TO: Planning Commission
FROM: Elizabeth A. Hude, AICP, Community Development Director
SUBJECT: 200 E. Kipp - Gestamp
DATE: August 5, 2021 - FINAL

Alan Boyer, LSG Engineers & Surveyors, on behalf of Gestamp Mason, LLC has submitted a request for approval of a Special Use Permit and Final Site Plan for construction of a new 49,200 sq. ft. addition on an existing 624,780 sq. ft. building to be used as a Finish Goods Product Storage (Low Bay) and to perform other related site improvements on property located at 200 E. Kipp Rd, parcel 33-19-10-16-100-024. The parcel is zoned M-2 General Manufacturing District.

Pursuant to the City of Mason Zoning Ordinance (Chapter 94 of the Code of Ordinances) and in particular, Section 94-2 and Section 94-226 (c), we have reviewed the plans for the Gestamp 2021 expansion as prepared by LSG Engineers and Surveyors dated July 2, 2021.

FILE	C6-1.DWG
DESIGNED BY	ADB
DRAWN BY	AJ
CHECKED BY	ADB
DATE	MAY 24, 2021
SCALE	
HOR.	N/A
VERT.	N/A
PROJECT NO.	2679
SHEET NO.	C6.1

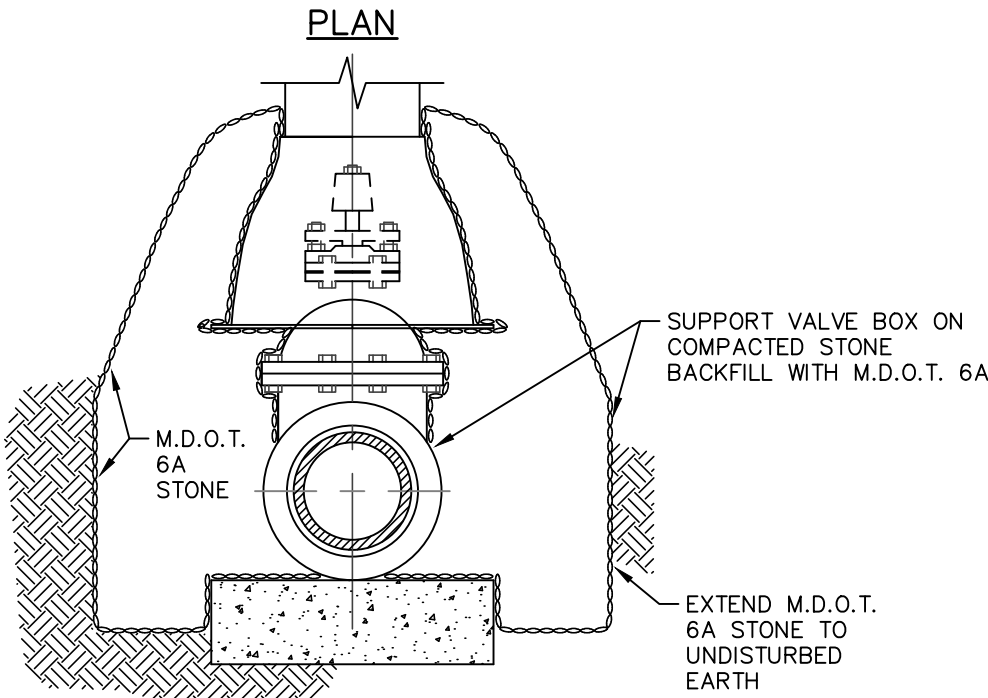
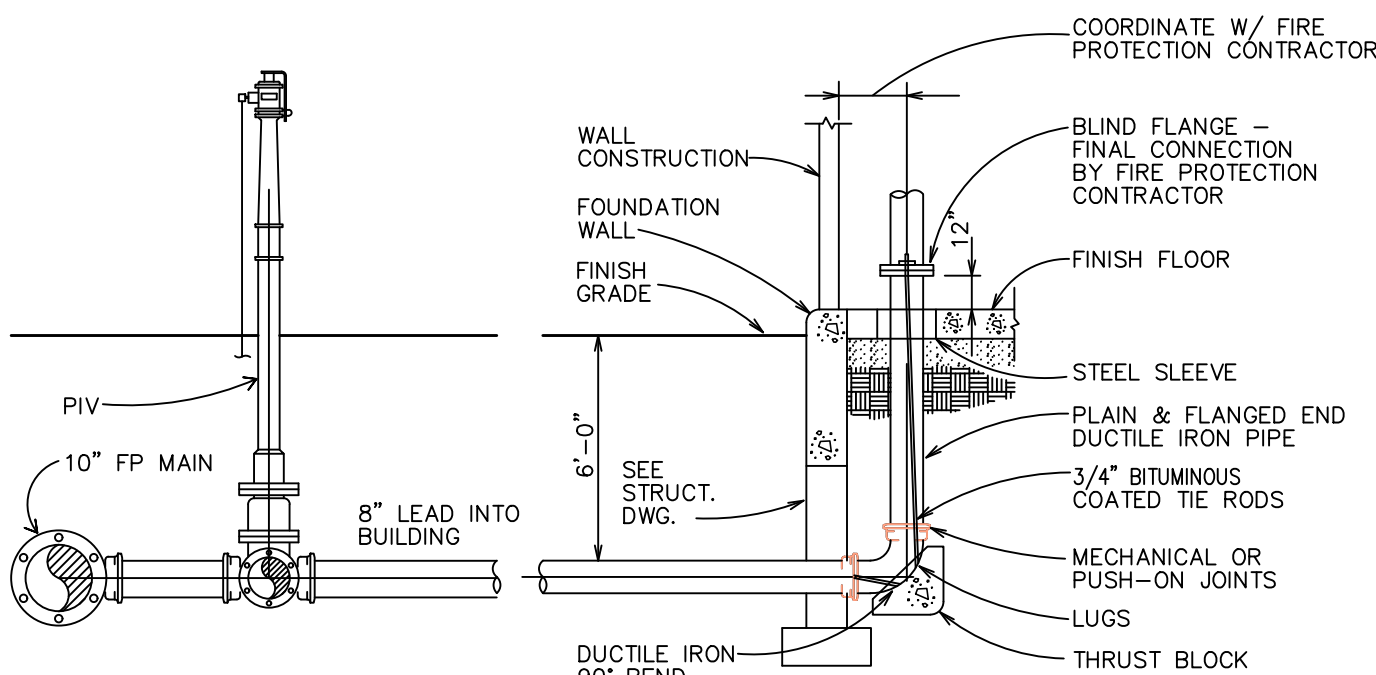
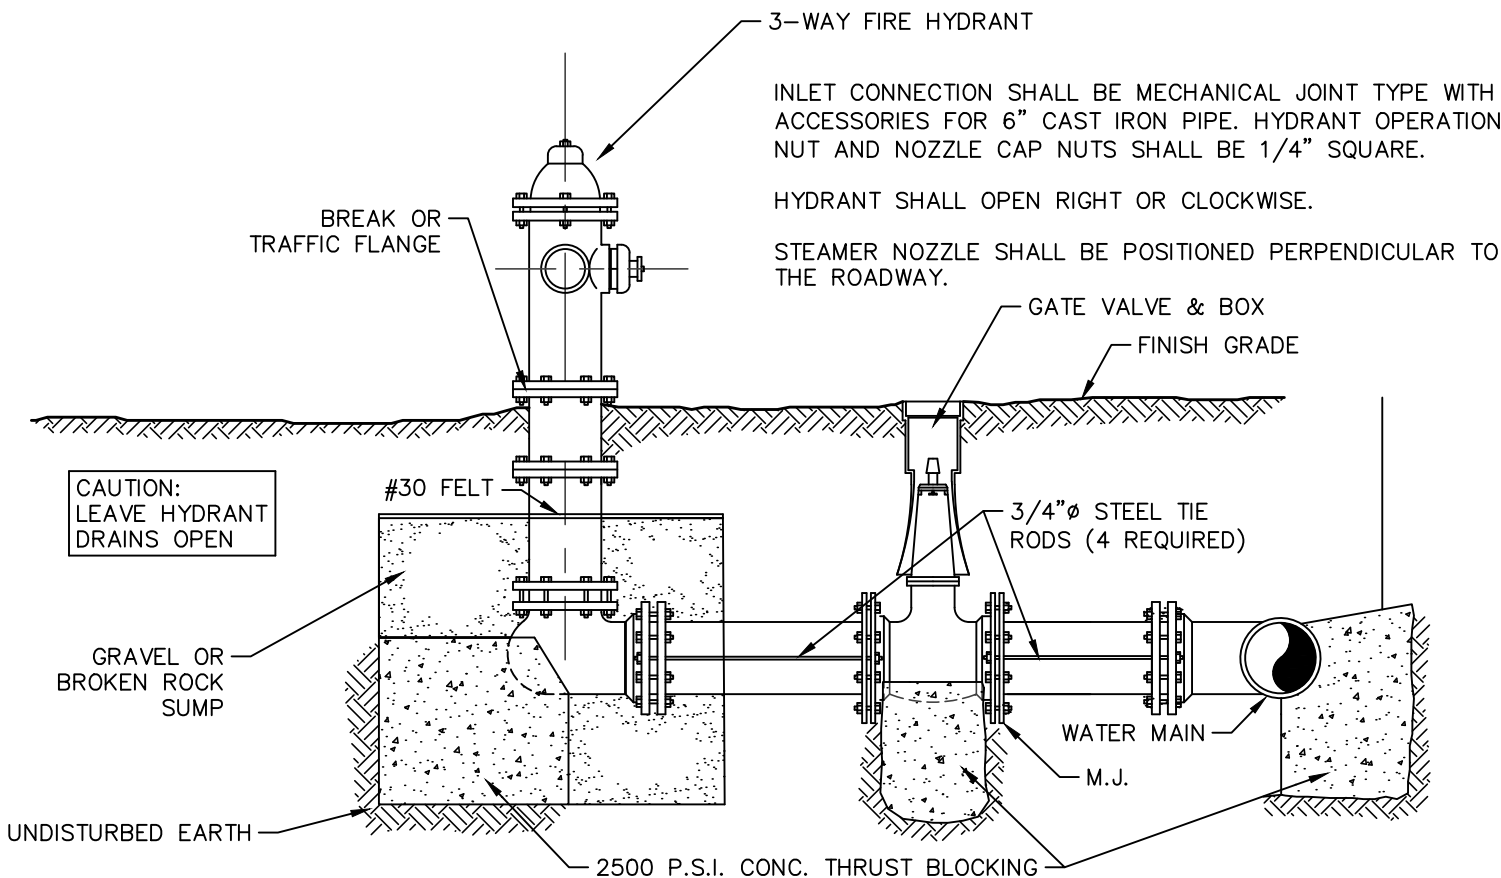
5. The fire hydrant, as shown on Plan Sheet C6.1, shall be revised to note the hydrant shall be EJ Model 5BR with two (2) 5-inch Storz connections. Hydrants shall be painted yellow.

6. The plans should also note the valves on the 10-inch water main shall be EJ Flow Master resilient seat gate valves.
7. Pursuant to Section 85-152 of the Code of Ordinances, any storm drain that will be within the footprint of the building expansion shall be sealed in such a manner as to prevent the discharge of any untreated waste into the storm system and ultimately into waters of the State. Any floor drains with the building shall be connected to the sanitary sewer system.

SHEET
TS

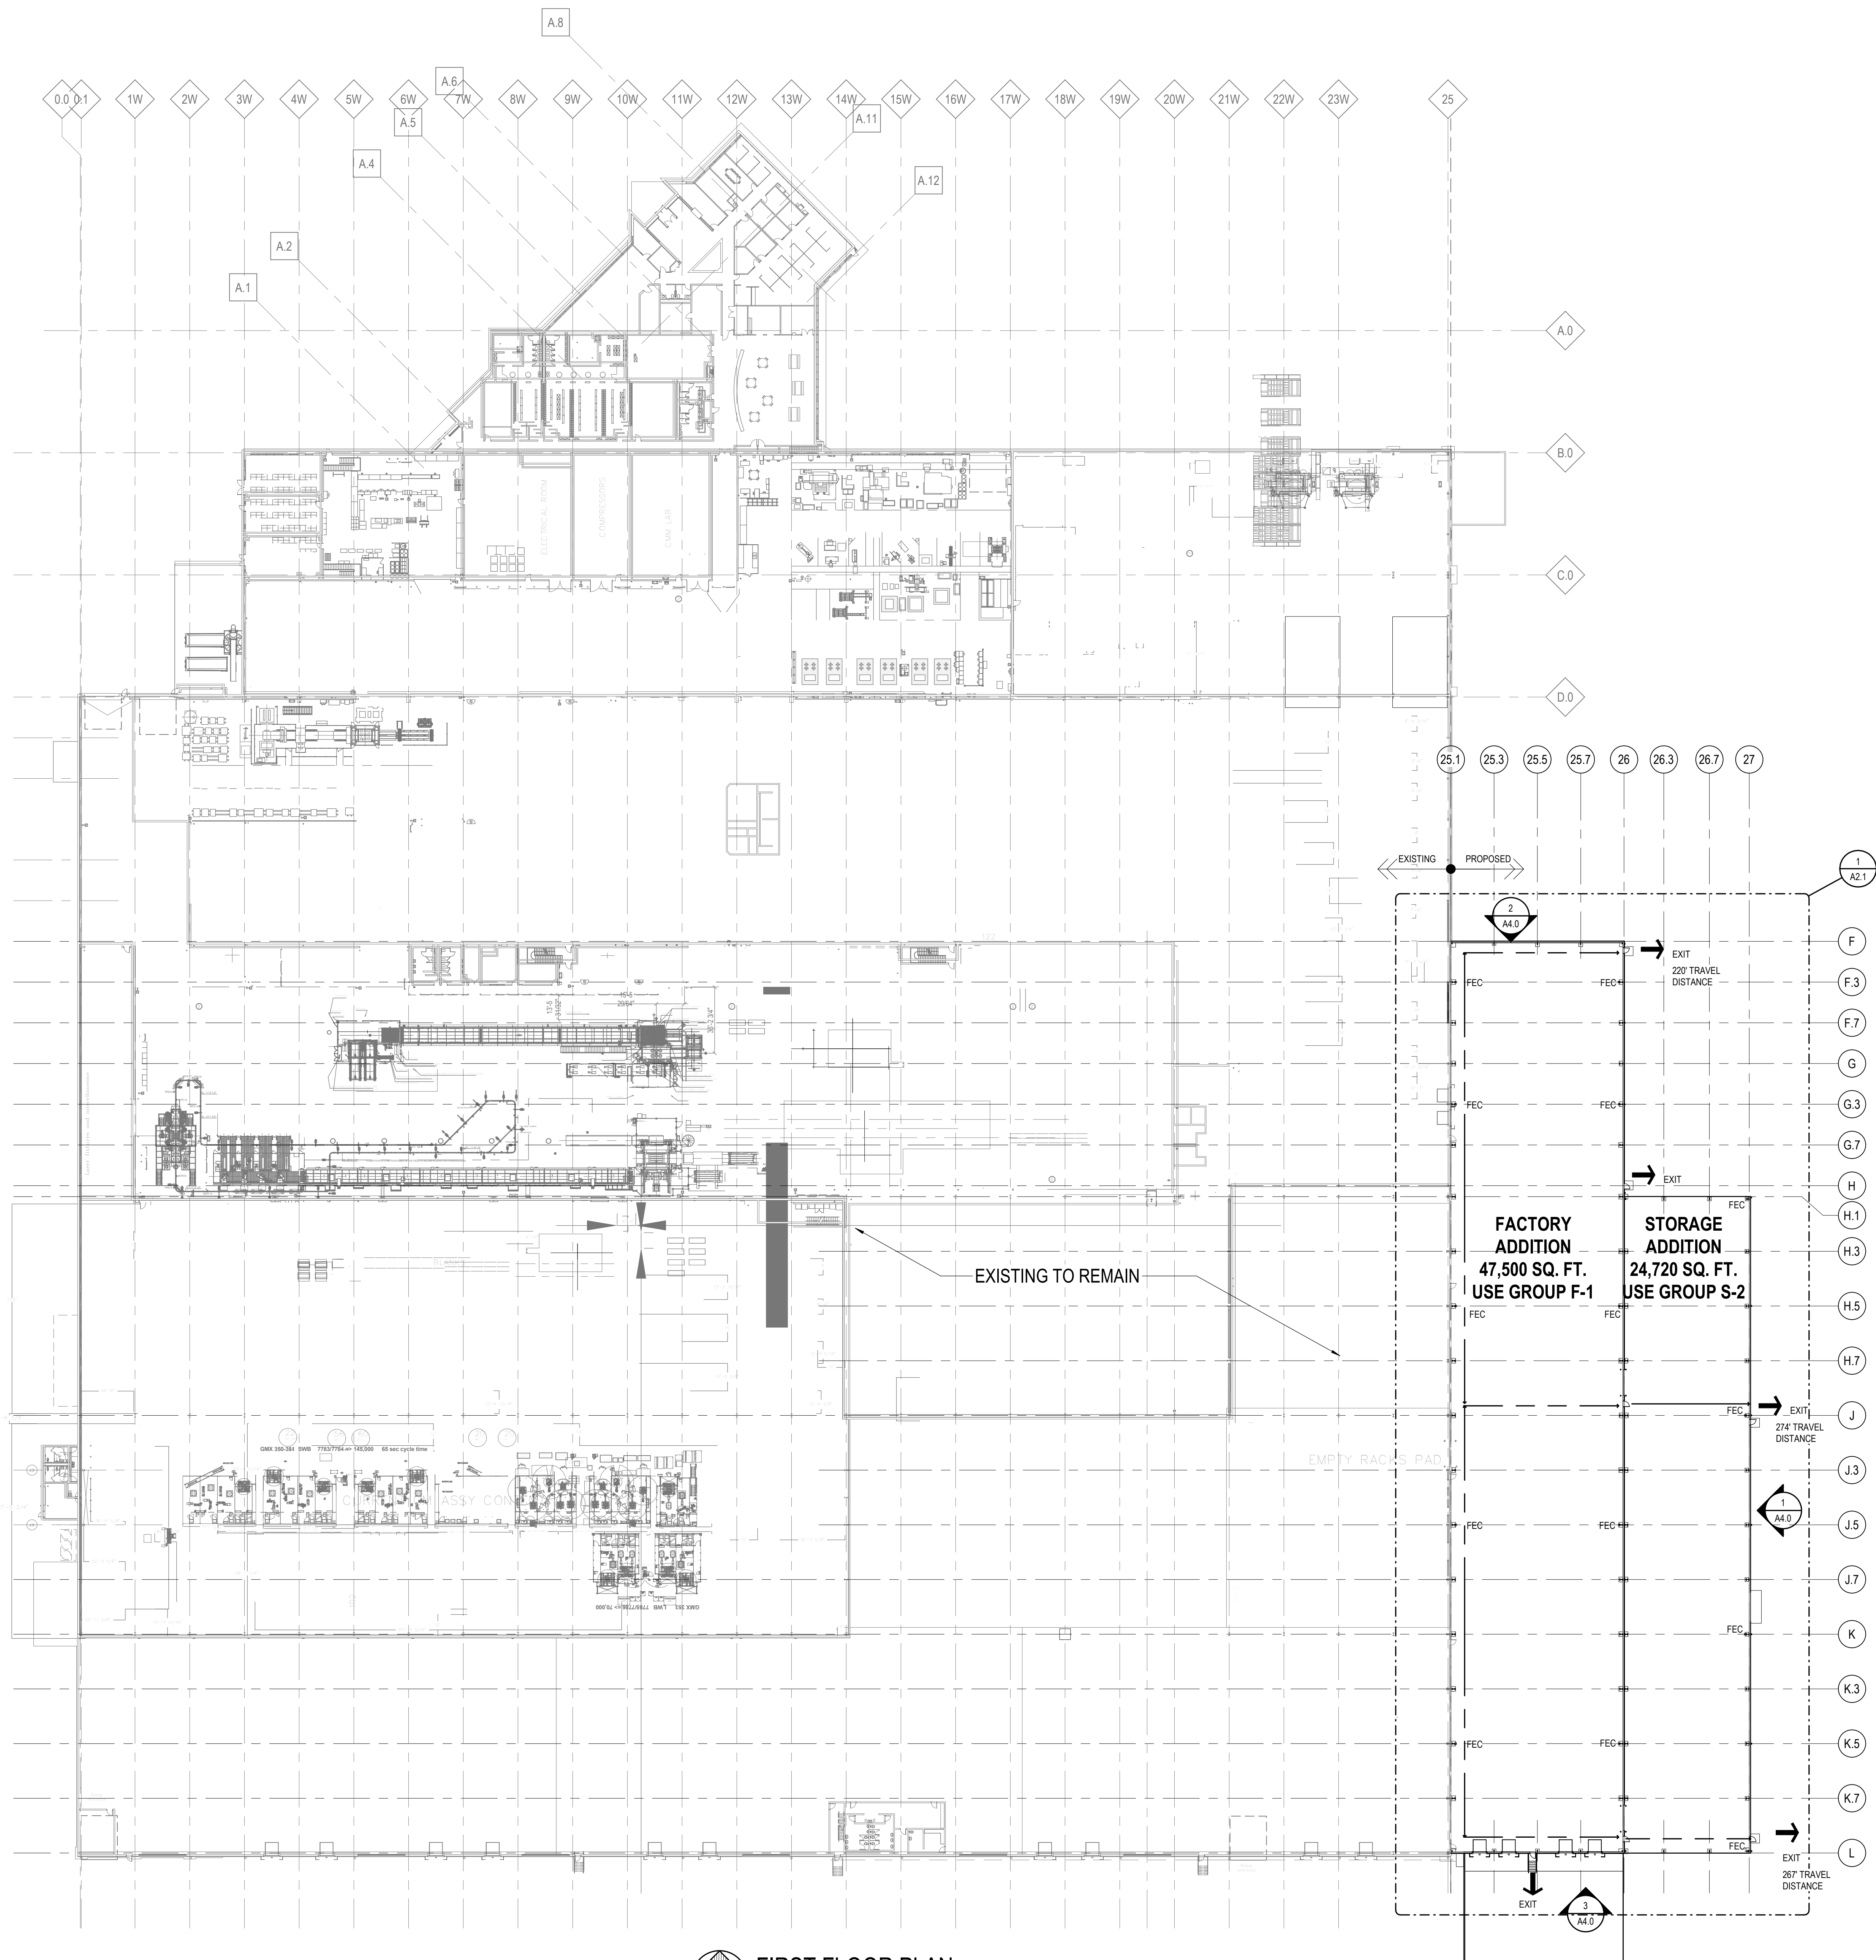
There is a discrepancy in total square footage of the addition. The application states 49,200 but the footprint on sheet A2.0 shows only 47,500 s.f. This will need to be confirmed prior to approval.
